Added harmonic filter in blue box below for 2.3/2.5/2.6 TTA modules:

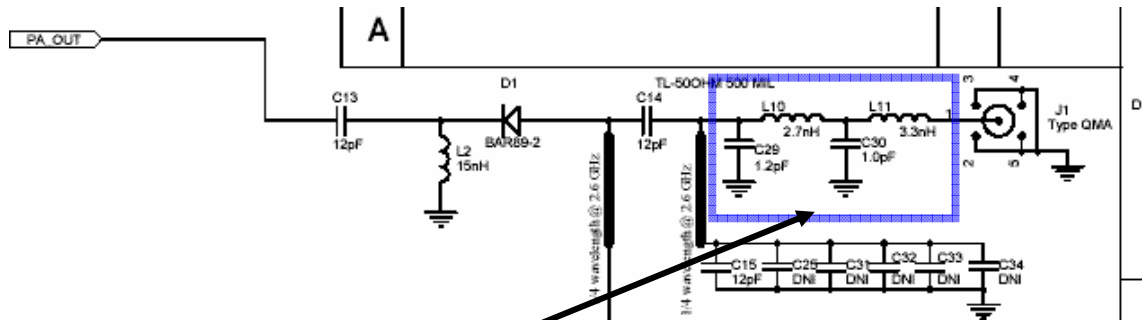
L10= 2.7nH, 08-00220-00R  
C29 = 1.2pF, 02-00207-00R  
C30=1pF, 02-00206-00R  
L11 = 3.3nH, 08-00163-00R

Also SUBBED in a Peak Devices part: 29-00046-00R for 2.3 TTA module  
29-00045-00R for 2.5 and 2.6 TTA module

Filter changed on 2.3 TTA module to frequency range 2300 to 2400 MHz....filter widened 5 MHz....old filter was 2305 to 2400 MHz...08-00209-01R is the new filter.

Filter changed on 2.5 TTA module to frequency range 2496 to 2620 MHz...filter widened 20 MHz on top end and 4 MHz on lower end...old filter was 2500 to 2600 MHz...08-02558-00R is the new filter.

Filter changed on 2.6 TTA module to frequency range 2595 to 2690 MHz...filter widened 4 MHz on top end...old filter was 2596 to 2686 MHz...08-02643-00R is the new filter.
